**Recall 15-064-TUS Transpec Stop Arm
NHTSA 15V886**

IMPORTANT SAFETY RECALL

January 2016

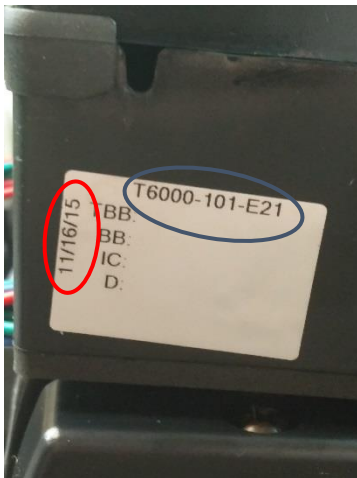
SMI has determined that, due to a process deficiency, the STOP decals on Transpec stop arms (part numbers T6000-, T6100-, T7000-) may not remain adhered to the plastic blade. Failure of the decal either in part or in total may cause the reflective surface to not meet FMVSS 131 standards. Without a reflective decal, the stop arms would have reduced visibility to other drivers, increasing the risk of a crash.

Check the label on the bottom of the Transpec stop arm (circled below in red) for dates May 1, 2015 through October 19, 2015. Stop Arms built within this date range are subject to the replacement campaign.

Transpec stop arm service kits will be sent to you upon request and will include complete instructions on the removal and reinstallation of the defective components. Removal and reinstallation of each Transpec blade can be accomplished in **15 minutes**, for which SMI will reimburse installers **\$30.00** for each remedied stop arm.
